Subject: East Altamont Energy Center Application for Certification
Data Request Response Set #1 (01-AFC-04)

East Altamont Energy Center
Data Requests and Responses (01-AFC-4)
Set #1

EAST ALTAMONT ENERGY CENTER DATA REQUEST AND RESPONSE SET #1 (01-AFC-4)

Technical Area: Visual Resources

Figure 7.1a

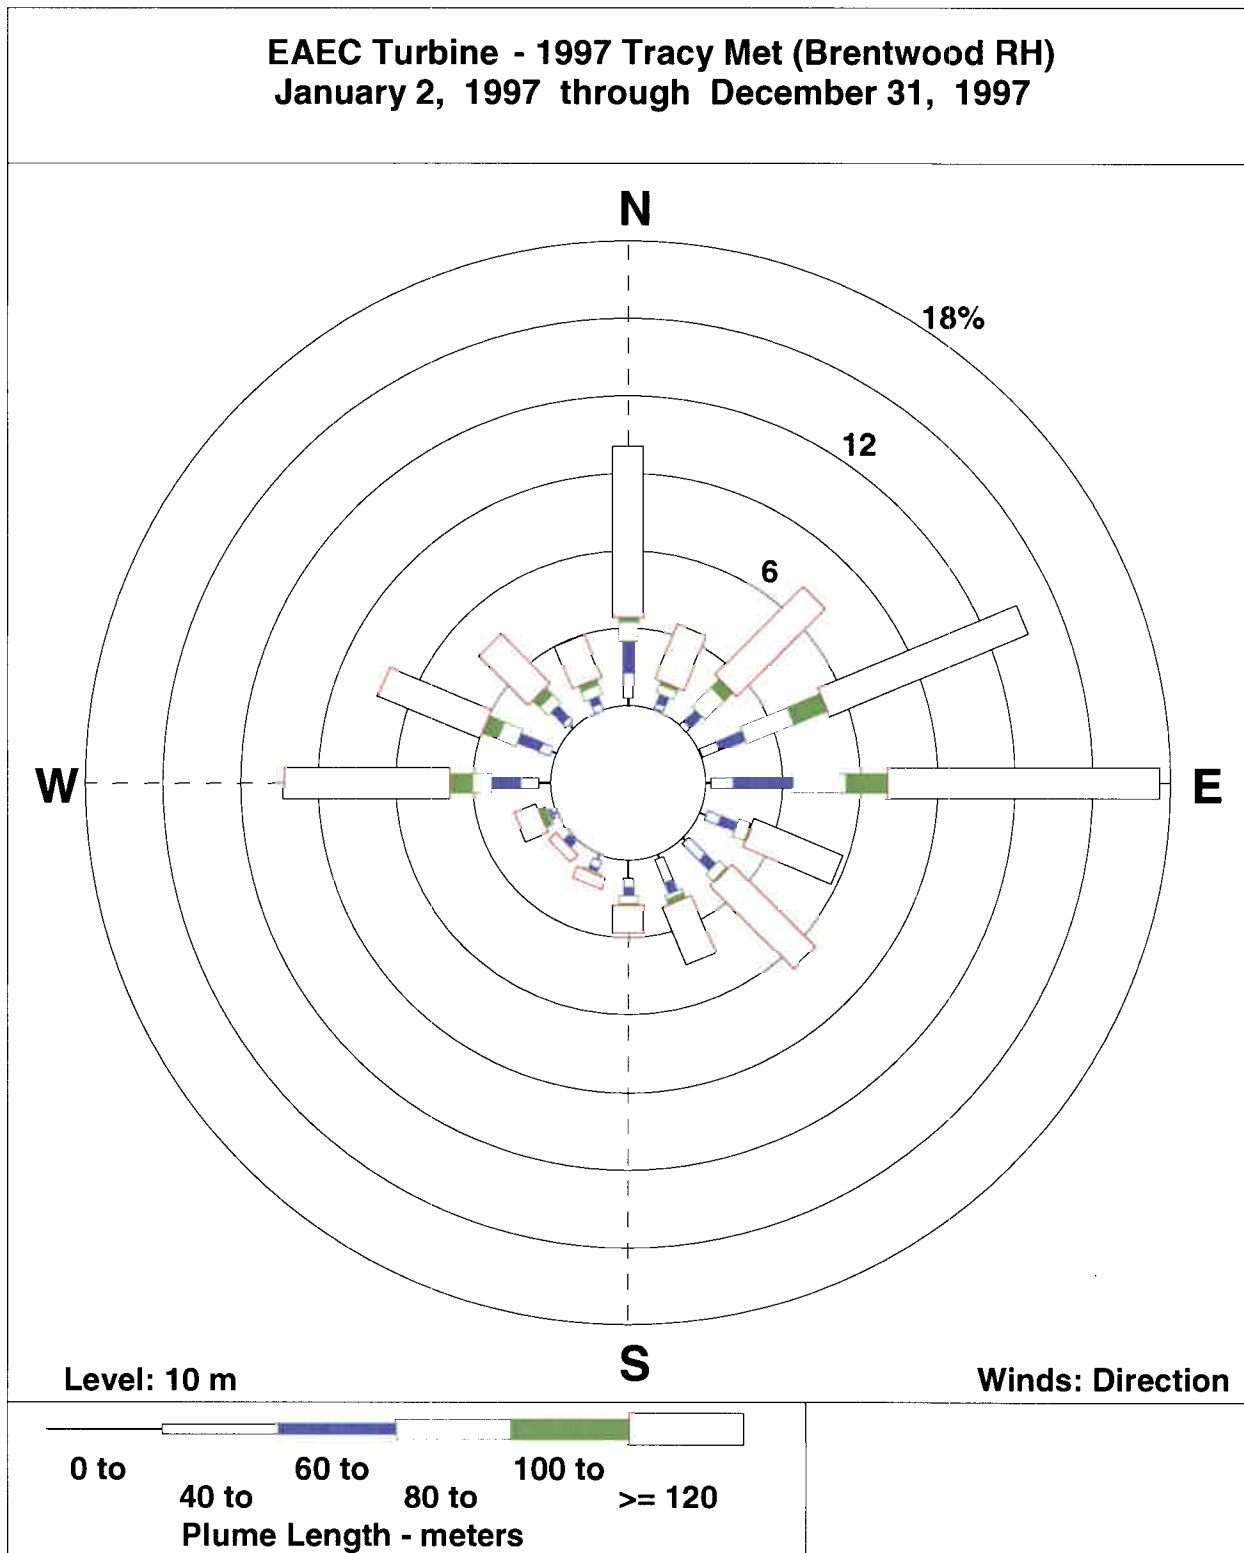
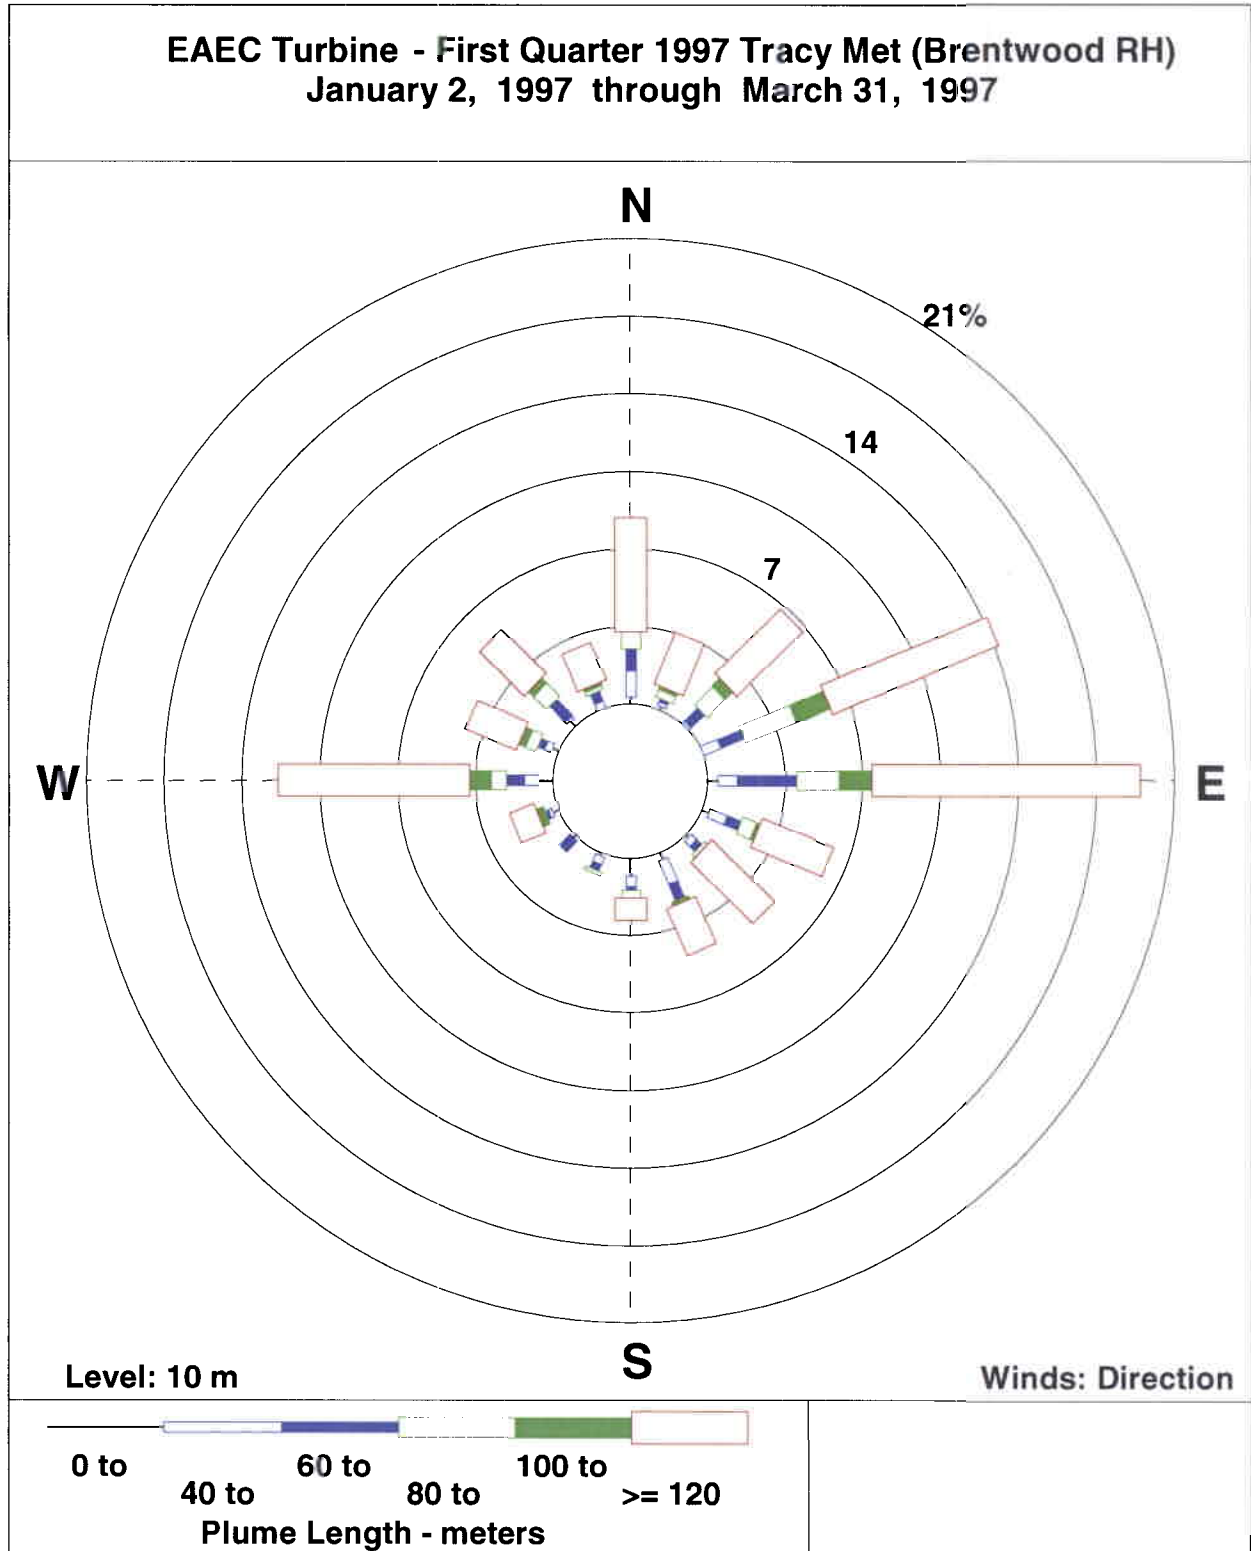
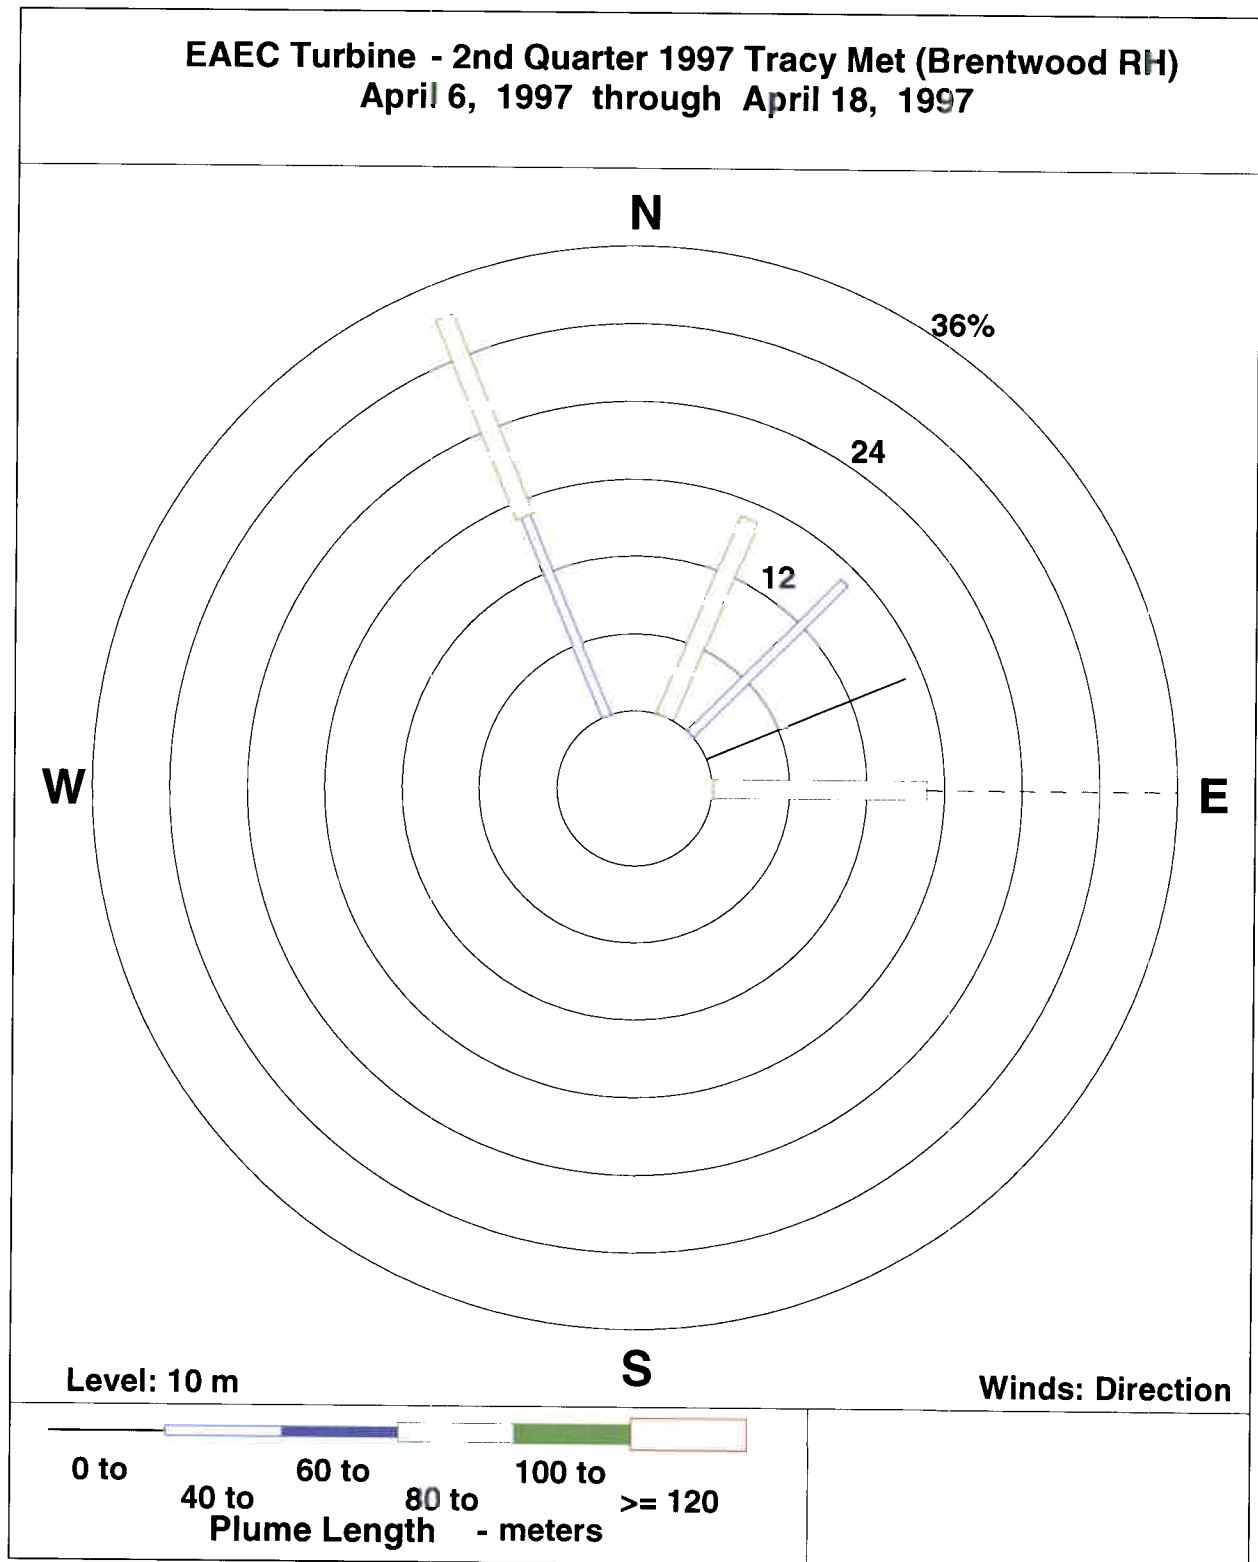
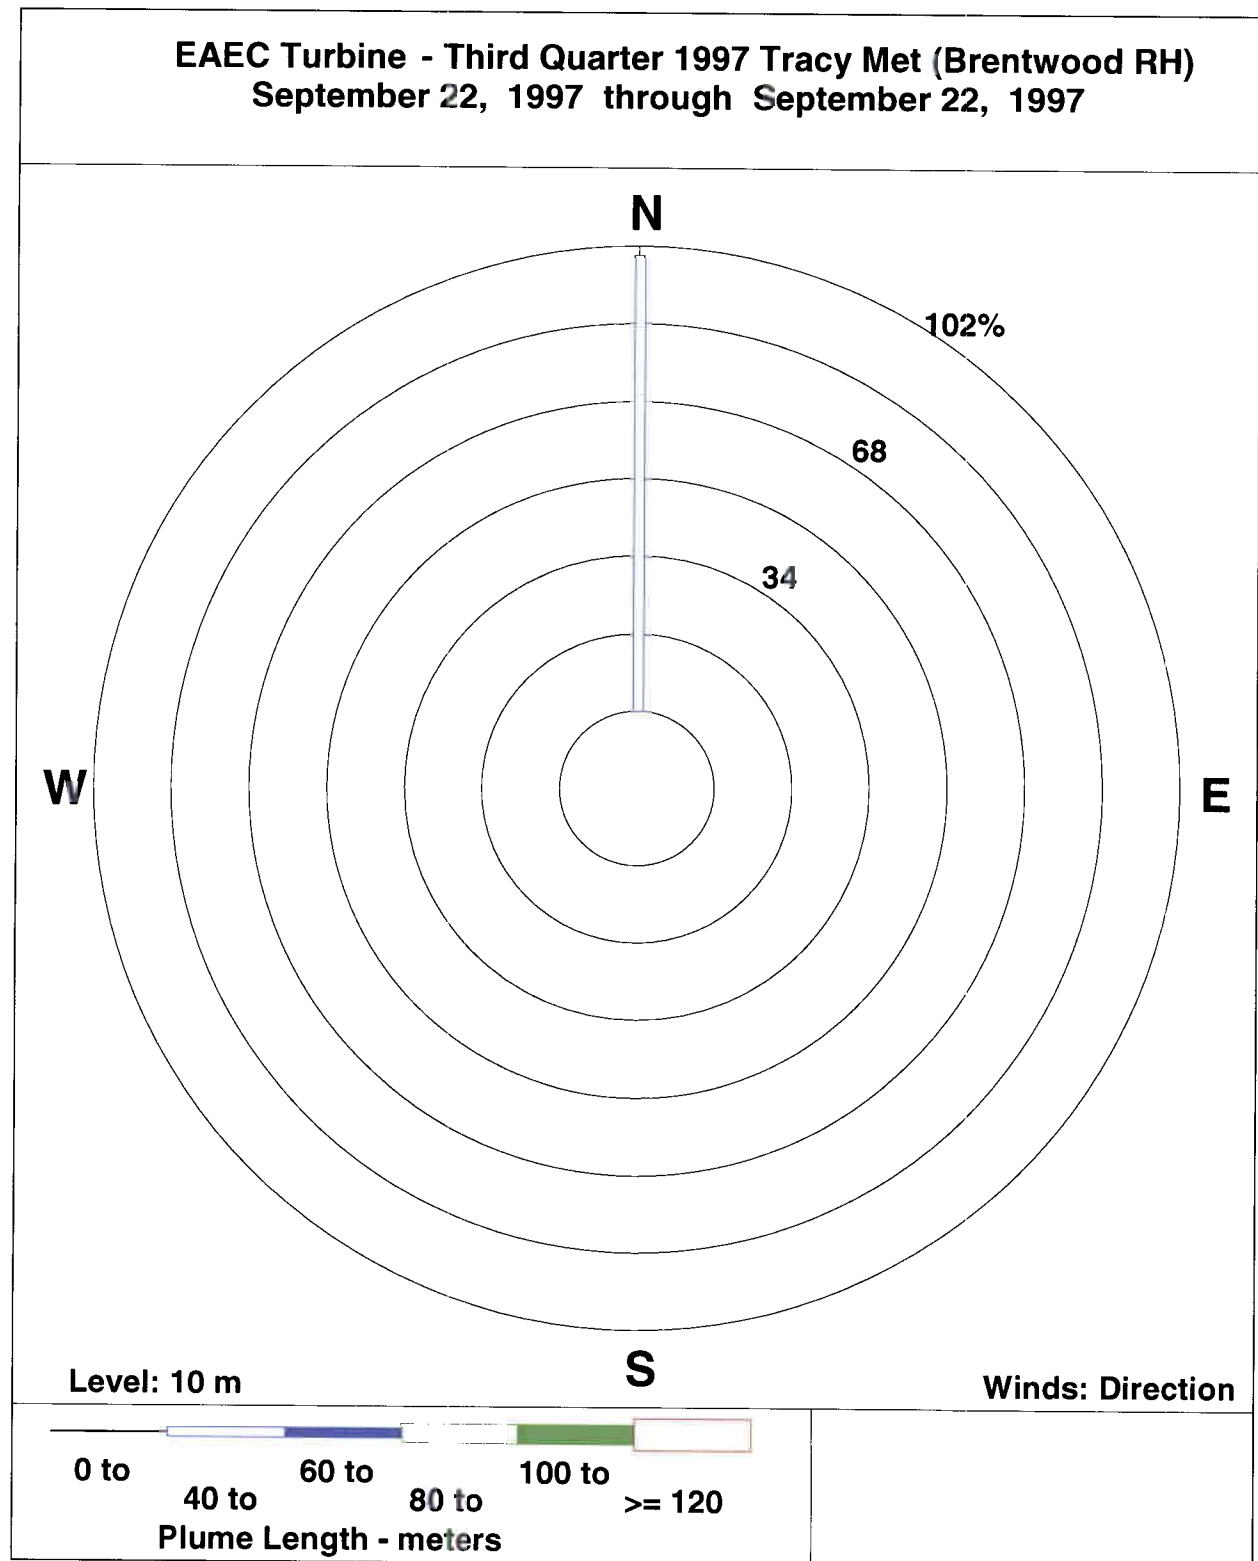
- a. The total number of daylight hours annually and seasonally;

Response: Table VIS-7.1 shows the number of hours per year that there is the potential for formation of a visible water vapor plume of various lengths from each HRSG stack. The analysis assumes that each HRSG is operated for 8,760 hours per year. During the hours between 6 a.m. and 8 p.m., the units are assumed to operate at full load with duct firing and power steam augmentation; during all other hours, the units are assumed to operate at full load, but without duct firing or power steam augmentation. The analysis was performed for each of the three years of meteorological data available.

A seasonal distribution of these hours is presented in the plume roses included as Figures VIS-7.1a through VIS-7.3e.
